**Re: Response to 1st Submission Comments
2868577 Ontario Inc.
Proposed Residential Subdivision
15544 McLaughlin Road
Town of Caledon
File No. DART 21T-23002C
Our File No. W22002**

The Town of Caledon's Transportation Team from the Engineering Services Department has provided comments to the Traffic Impact Brief dated July 28th, 2023 that was prepared by Candevcon Group Inc. in a letter dated January 22nd, 2024, which is attached.

**TRAFFIC IMPACT BRIEF
PROPOSED RESIDENTIAL SUBDIVISION
15544 MCLAUGHLIN ROAD
TOWN OF CALEDON**

SCALE: 1:500 DWG. No. PL-1
 DATE: FEB., 7th 2024 PROJECT No. W22002

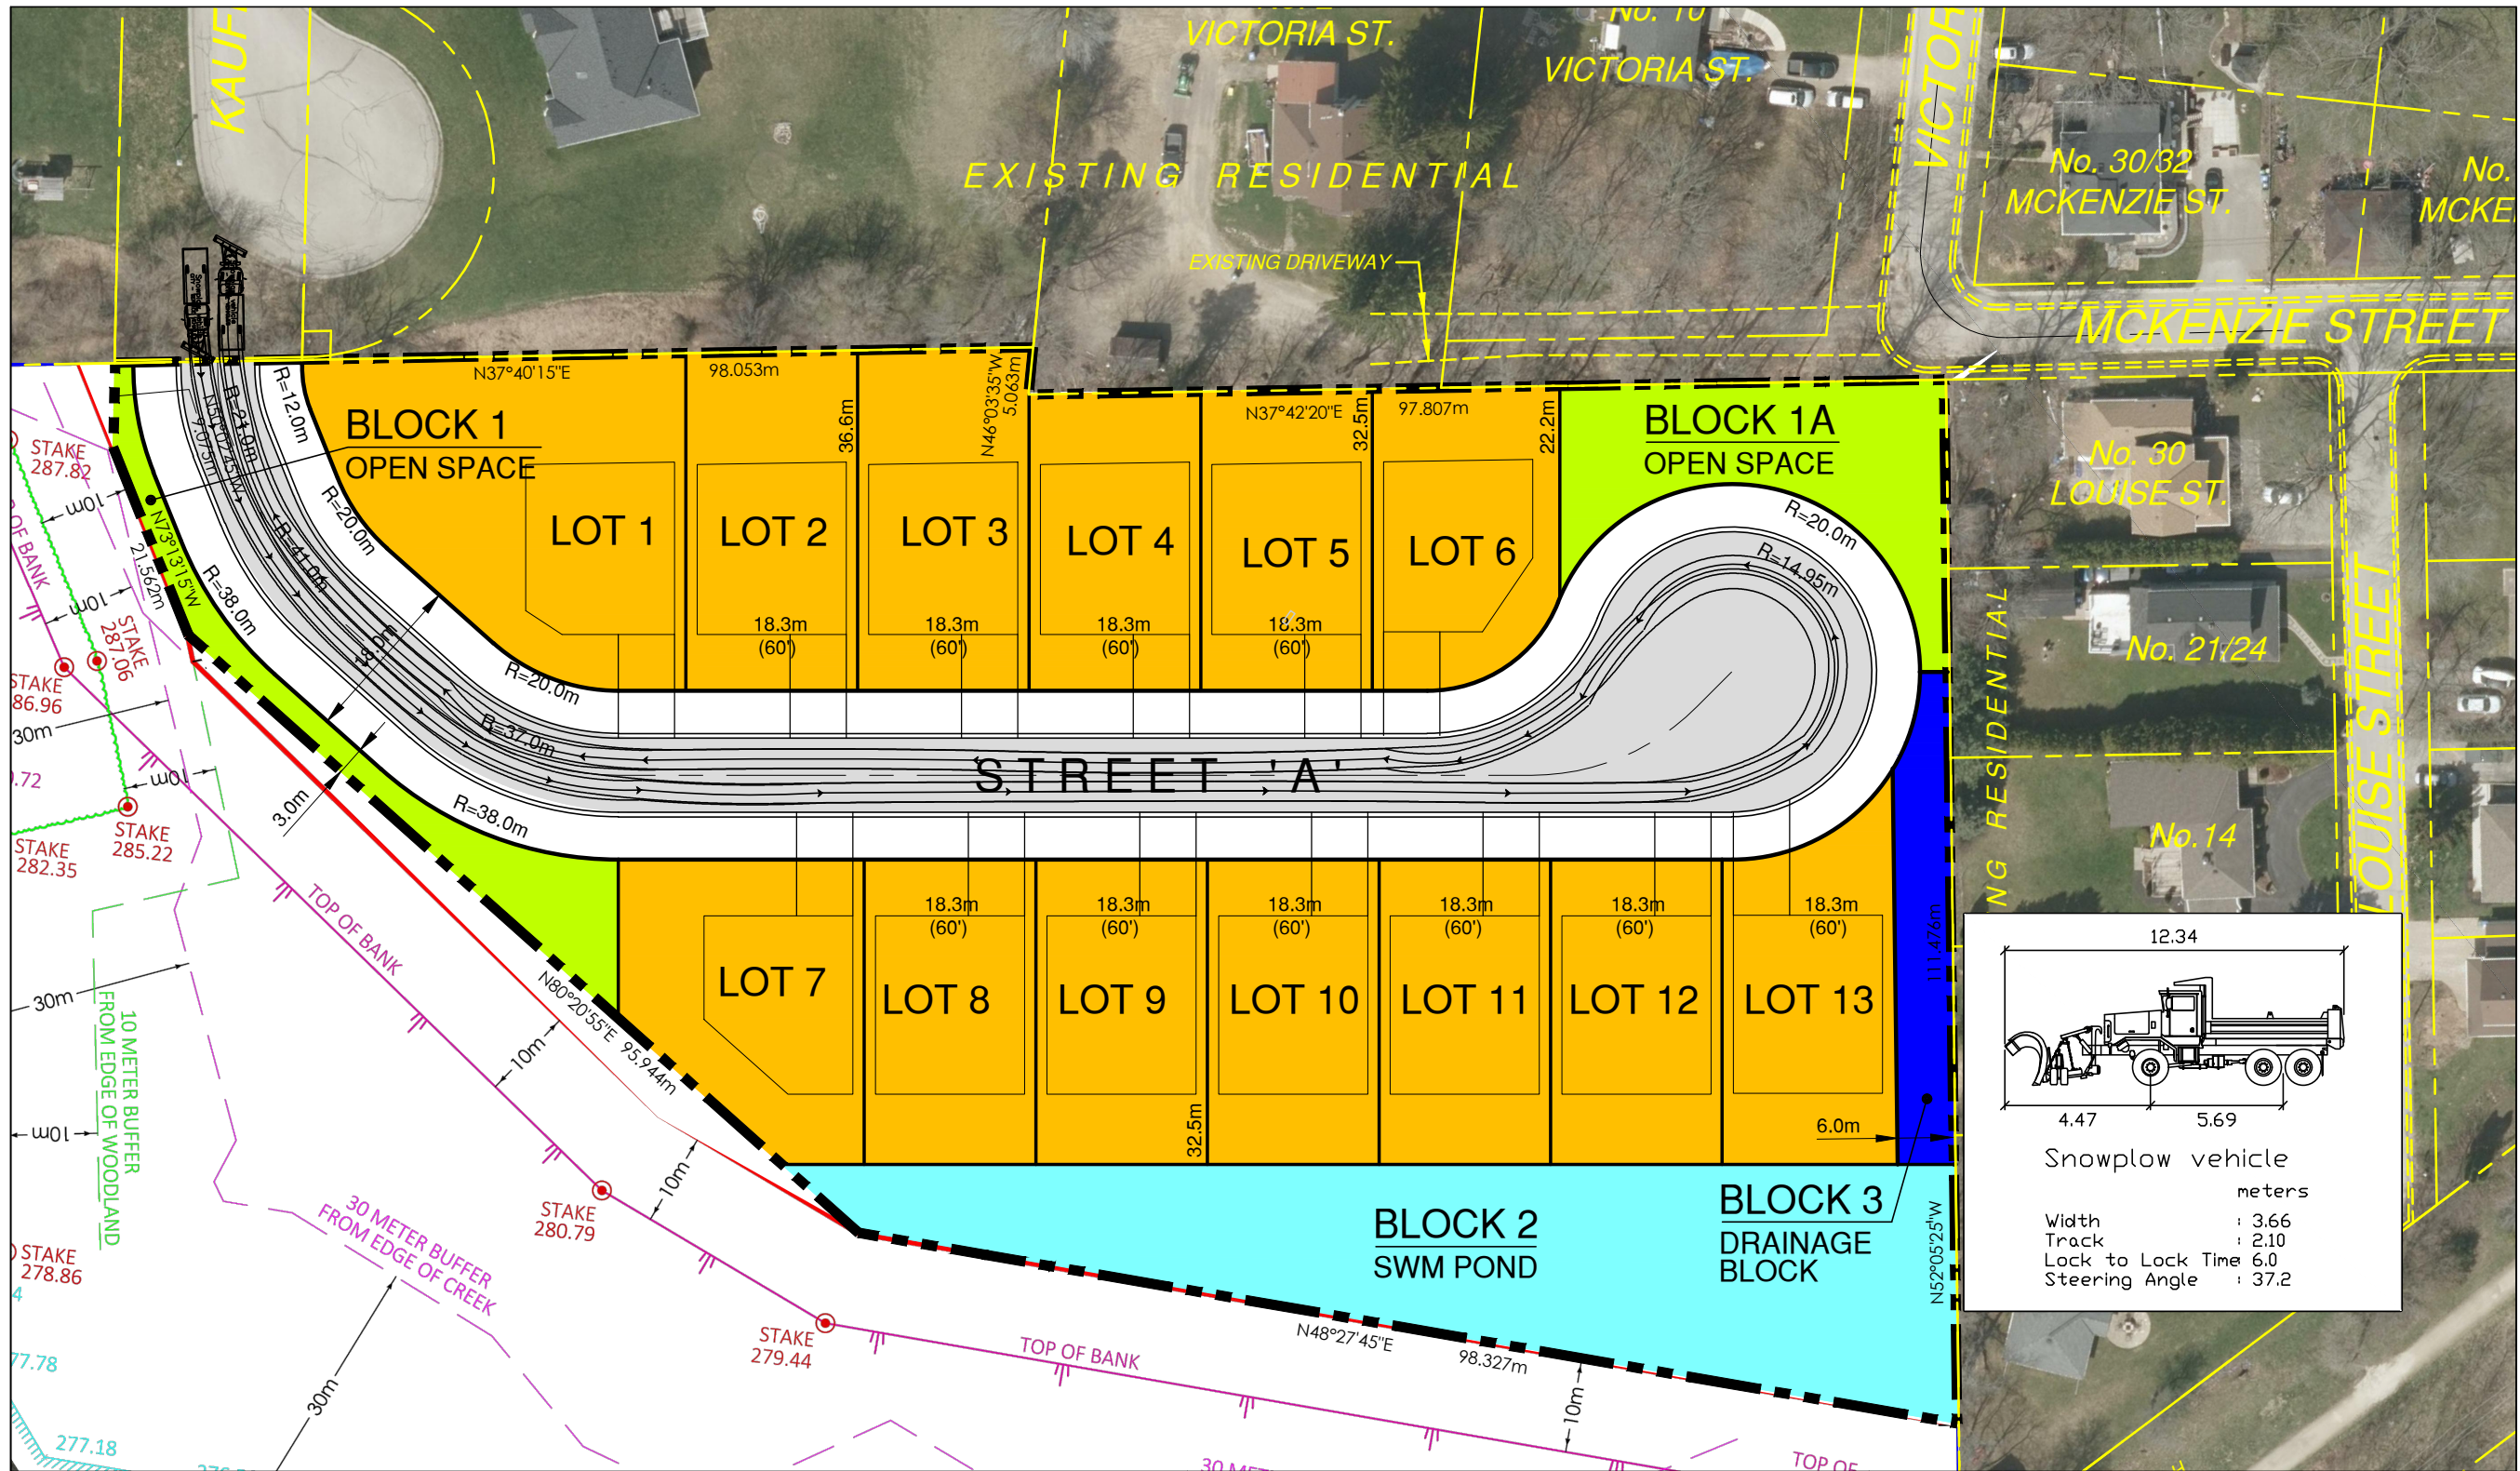
A sight distance assessment of the proposed roadways should be included in the report, including but not limited to the proposed access at Victoria Street and McKenzie Street.

Given the limited information on the proposed Victoria Street and McKenzie Street connection, including sight distance and pavement markings, Transportation Engineering Staff lack the required information to comment on the proposed connection. Please submit a comprehensive pavement markings and signage plan, aligning with Ontario Traffic Manual Guidelines and Town of Caledon Traffic By-Law 2015-0058. This plan should justify the proposed traffic controls for the proposed Victoria Street and McKenzie Street connection.

This intersection has been removed in the update to the Draft Plan of Subdivision, which is attached for reference.

This intersection has been removed in the update to the Draft Plan of Subdivision.

DATE:	JULY 25th, 2024	JOB No.	W22002
DESIGN:	B.W.	FIG. No.	1
SCALE:	1:750

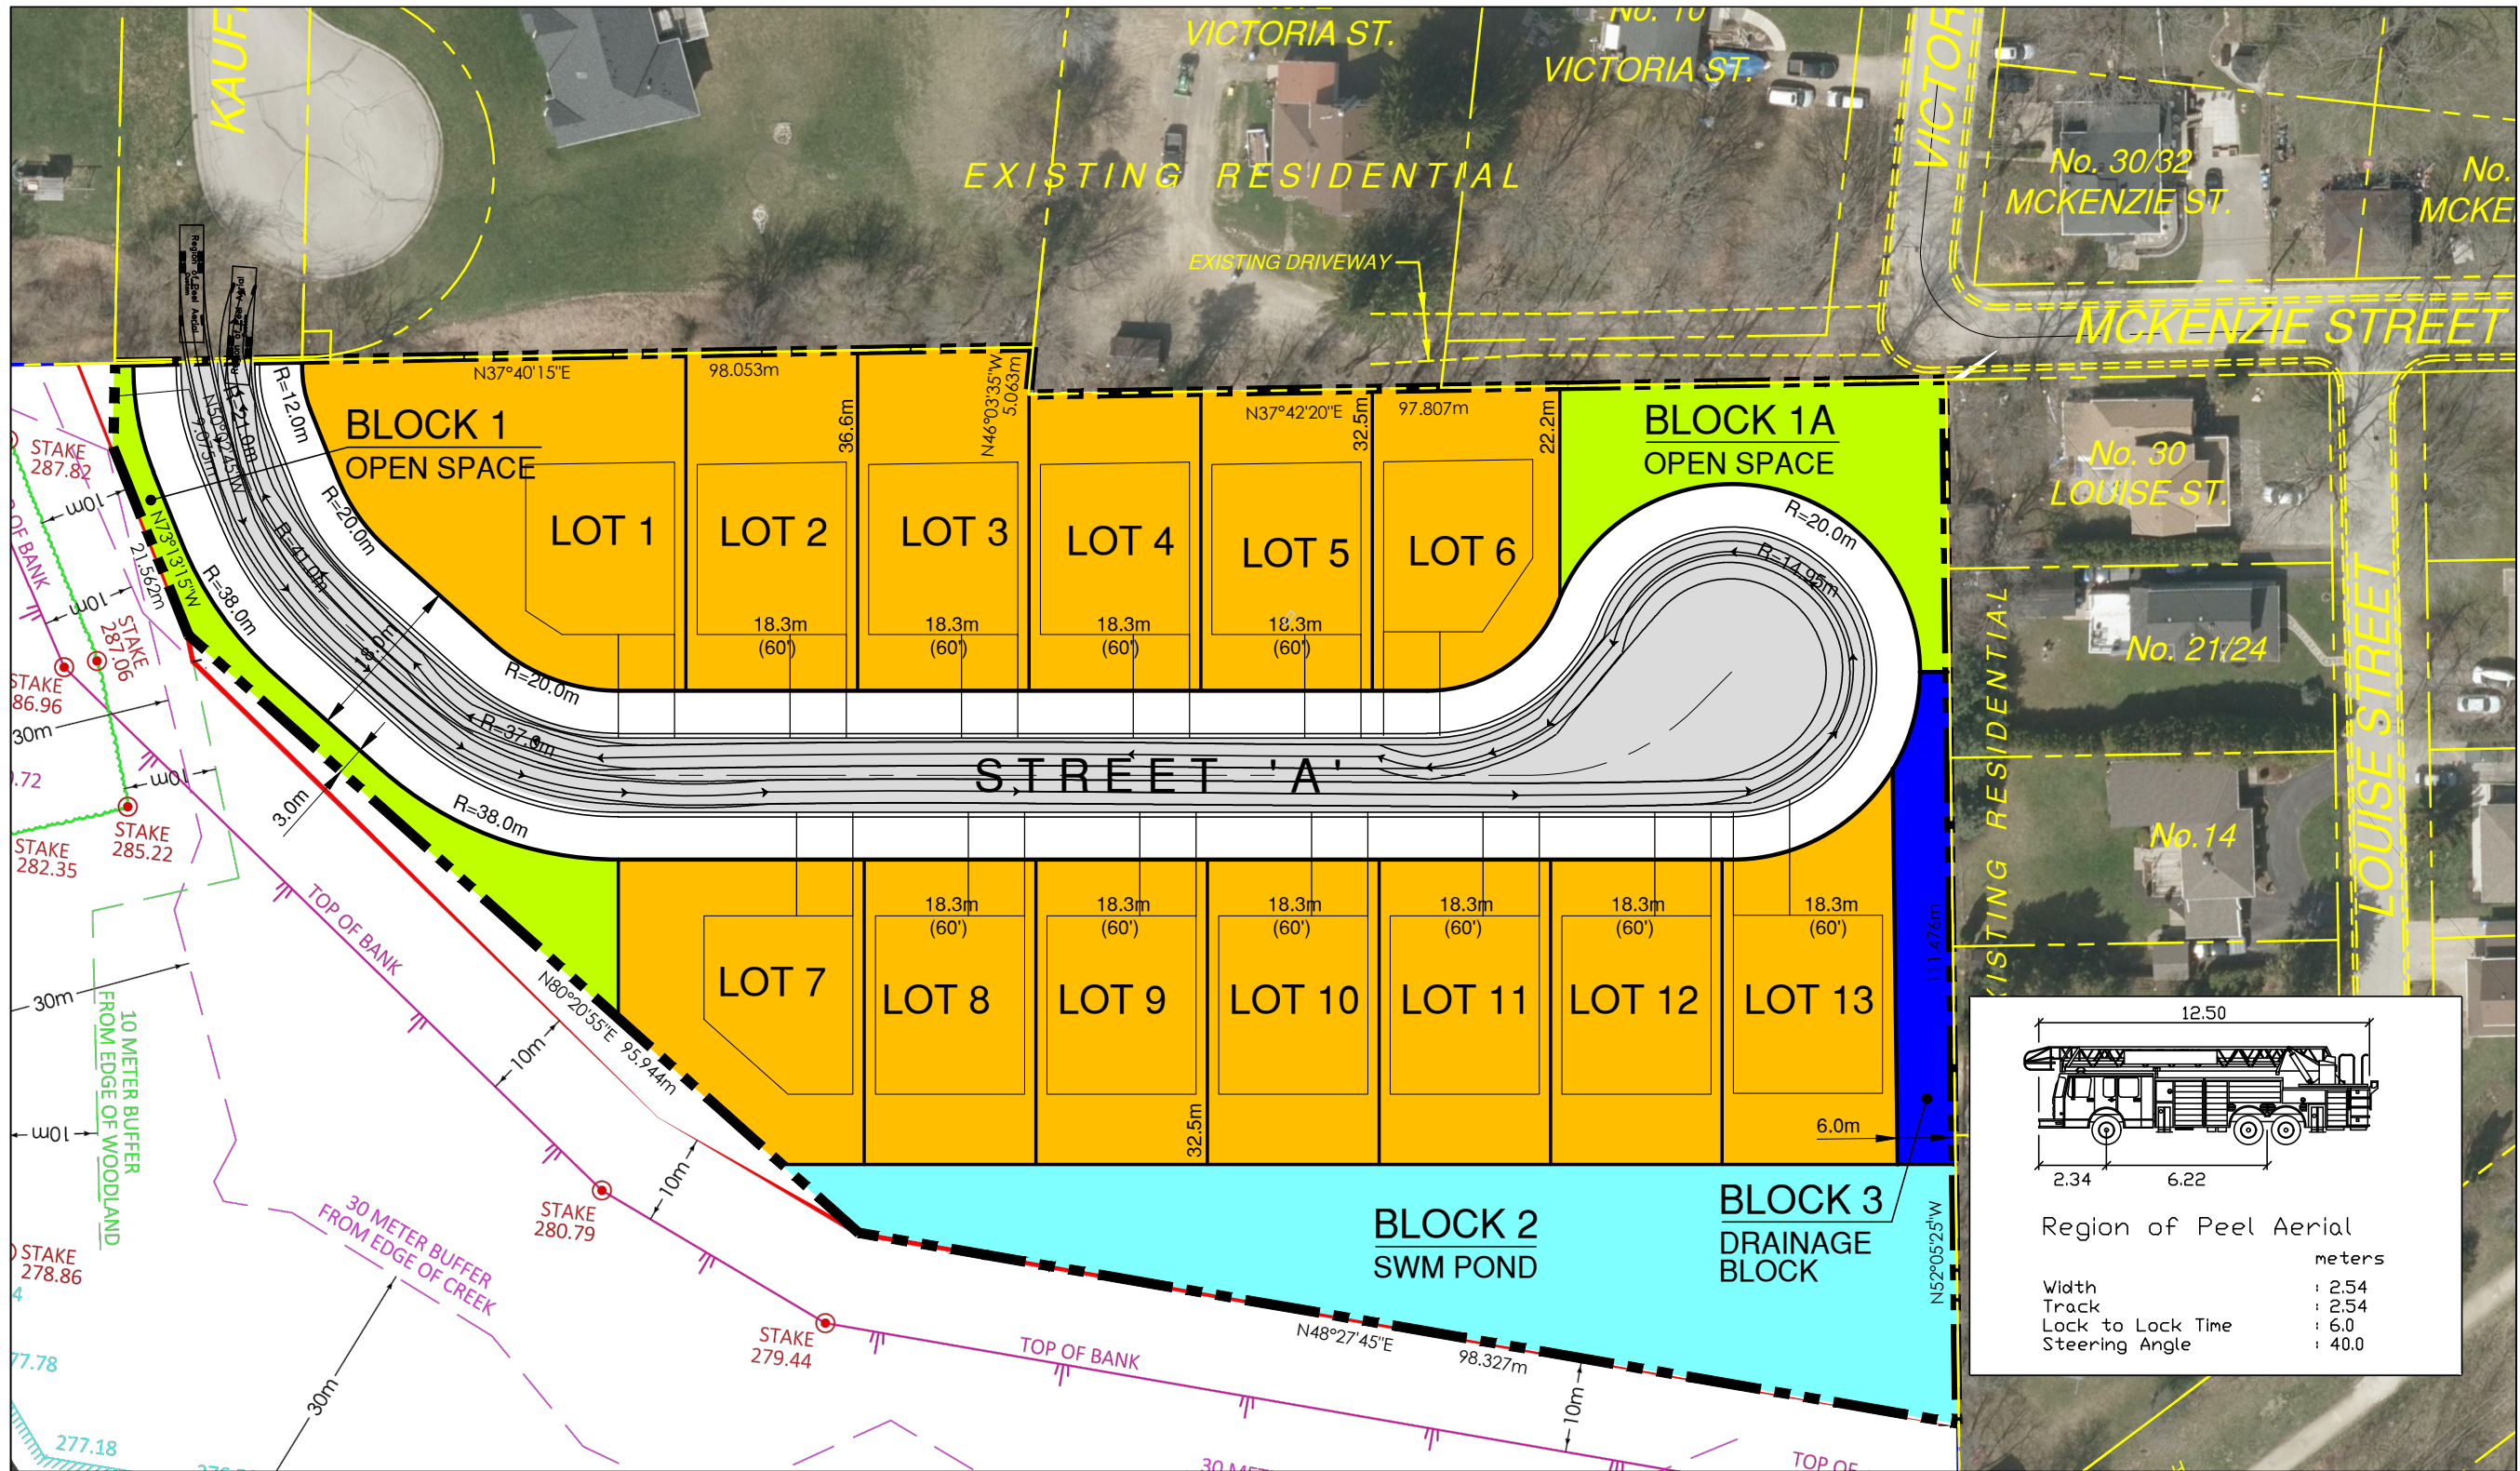
Please provide an AutoTURN assessment demonstrating snowplow and fire truck maneuverability. Centerline Radii should be provided, including but not limited to the proposed connection with Victoria Street and McKenzie Street.

A swept path plan for snow removal (**Figure 1**) and fire emergency vehicles (**Figure 2**) is attached.
